July 1, 2016

**COMPILED BIDDER QUESTIONS FORWARDED FROM VA THRU 06/29/16:**

Questions and Clarifications: VA244-16-B-0593  
Relocate and Modernize Community Living Center Project 540-12-103

Date: SHEET ISSUED 07-01-2016  
 Project Number 244-12-R-0315  
 DRAWING No. **G1013**

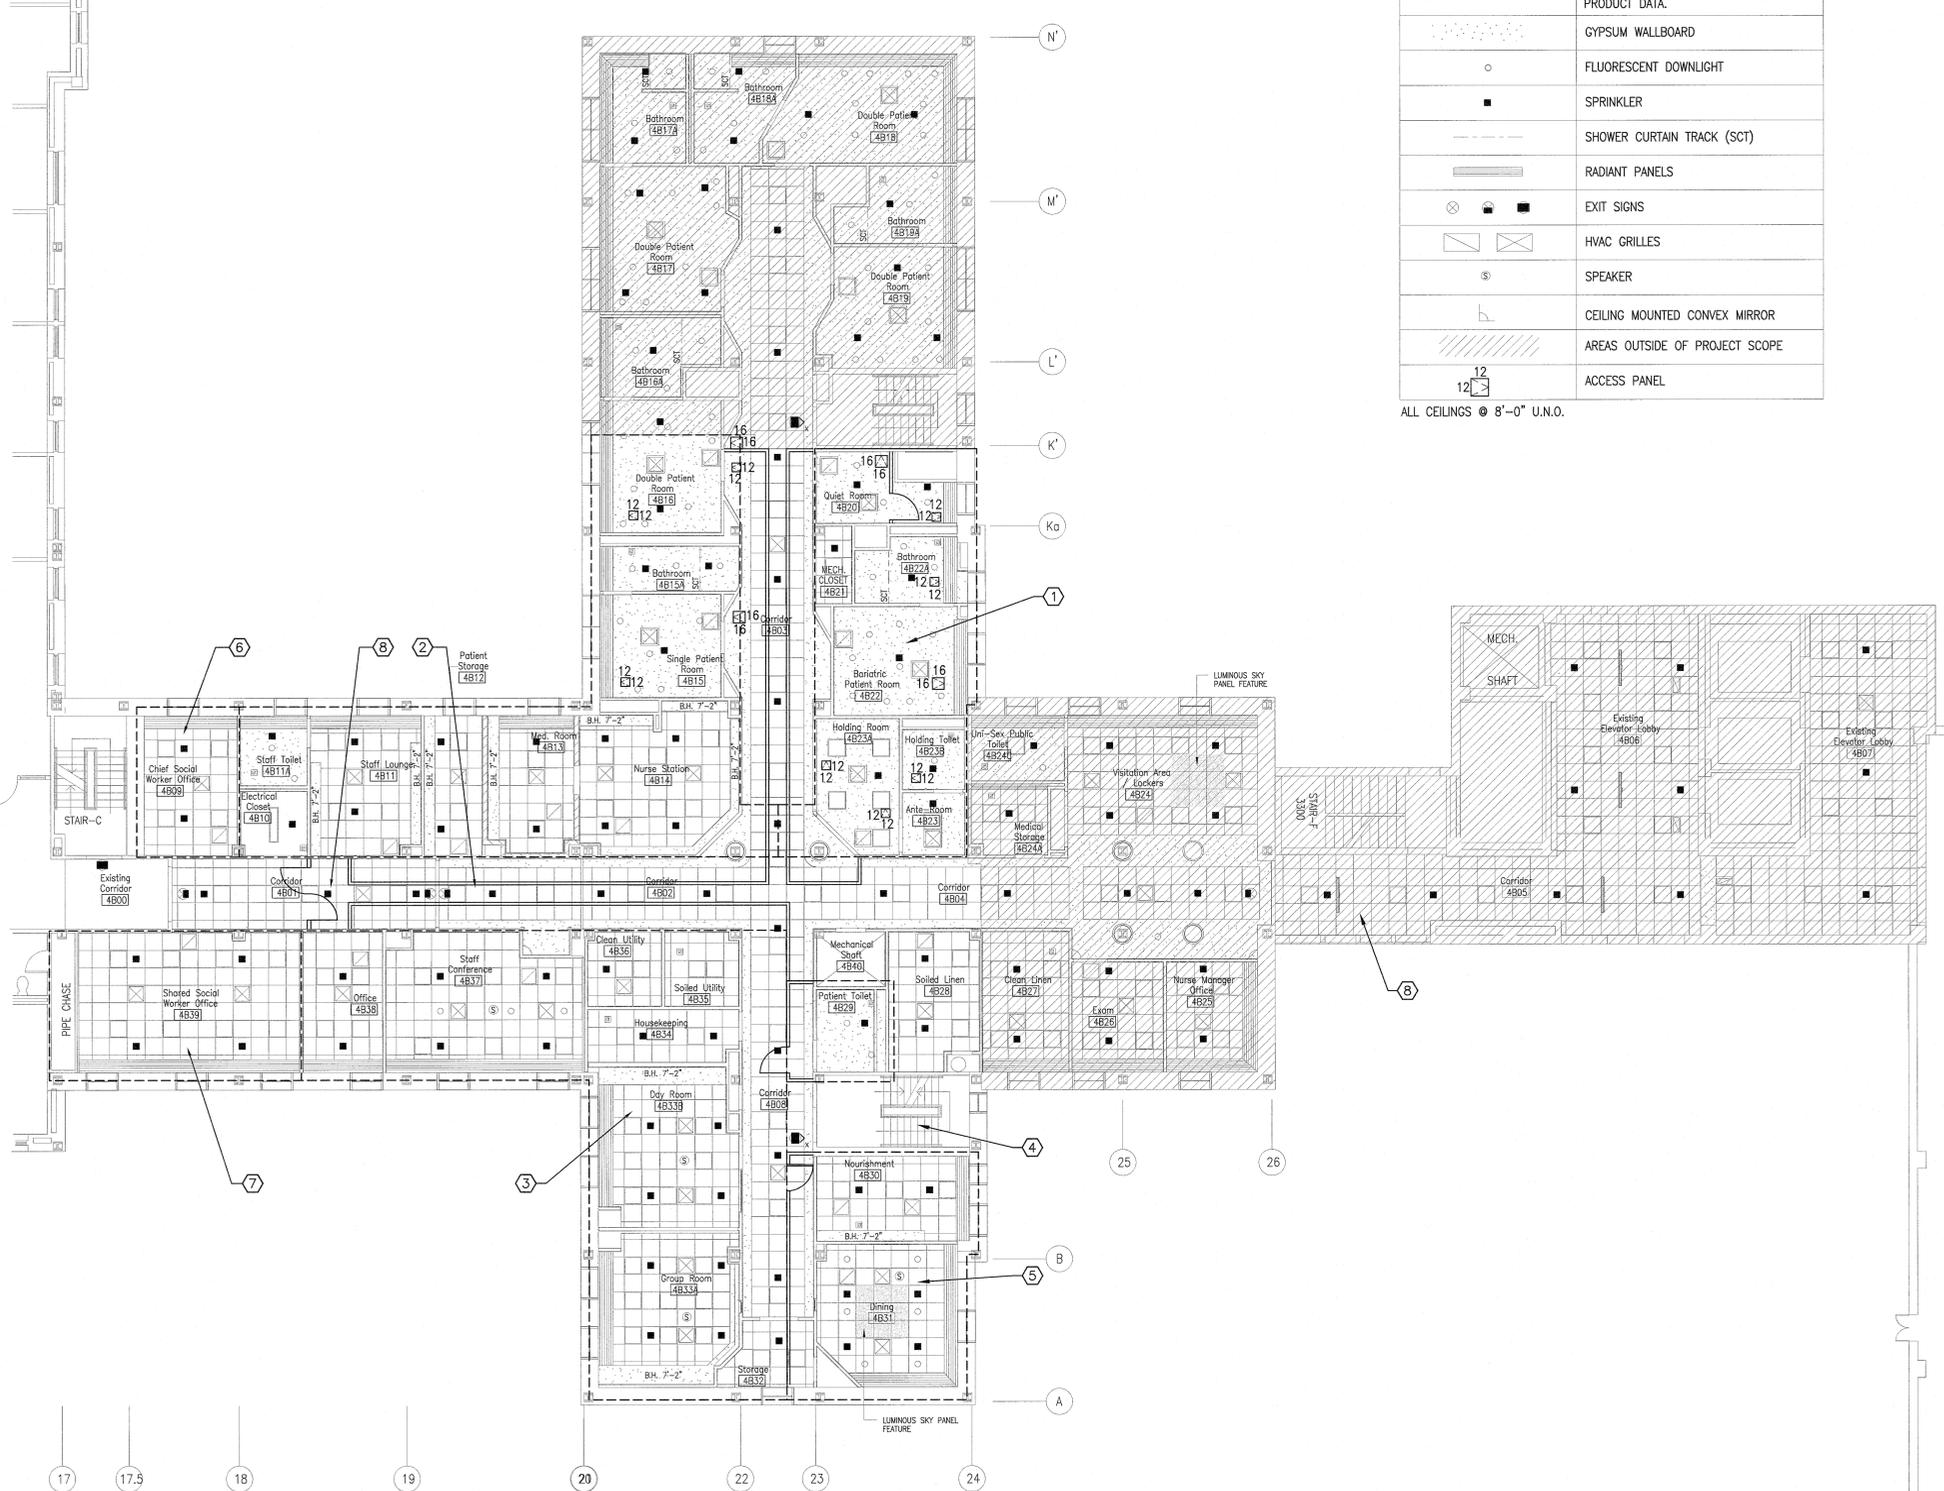
12. **Question:** In reference to the work indicated above the fourth floor ceiling. There are several areas in both phases and we assume that the floor will be occupied. In order to complete the work required in each phase, we assume that the VA will vacate parts or sections while the work is completed above the ceiling. How many sections can we anticipate for each phase? Drawing GI006 and GI008 have the areas shaded where work is to be performed. Can we assume those are the limits for each area?

**VA Response:** Per VA, while the shaded areas depict where the work is to be completed it does not represent the areas that will be made available to the construction contractor at one time. Contractors should anticipate having access to no more than two or three rooms at a time in occupied areas. 4B will be occupied 24/7. The VA will vacate as much space as is

practical while continuing patient care. 4A will be occupied 0800 to 1700. All utility shutdowns that will disrupt normal Medical Center operation shall be done outside normal Medical Center hours of operations.

DRAWING No. **AE104**

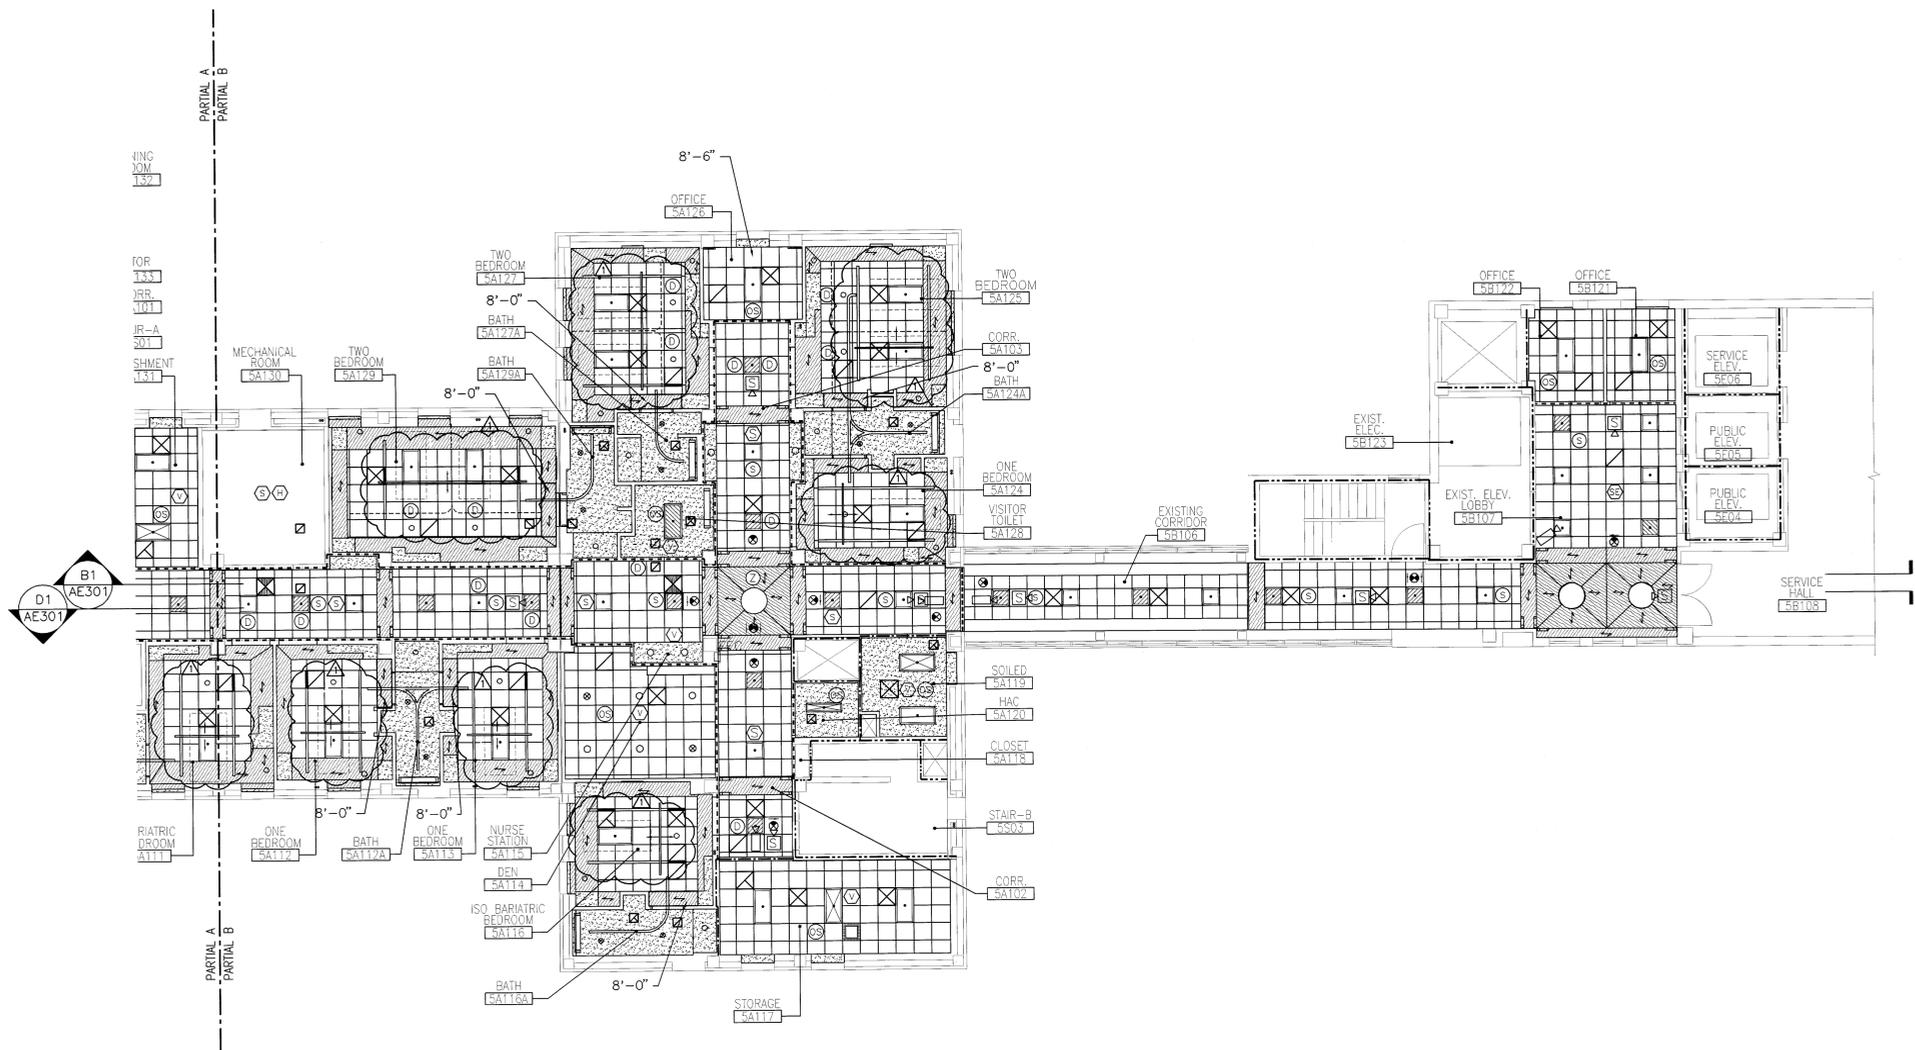
16. **Question:** Drawing AD102 does not indicate any demolition in the connecting corridor past column line 24, however Drawing AE104 indicates ceiling finishes in connecting corridor, elevator lobby and two offices that are not shown on the demo drawings. Are these existing to remain finishes beyond column line 24?

**AE Response:** On Sheet AD102's Demolition Legend, remove entire line labeled "Elevator Lobby" add replace with the following line:

Corridor / Elevator Lobby right side of CL 24	Corridor / Elevator Lobby right side of CL 24	1, 2, 6, 9, 11, 14
---	---	--------------------
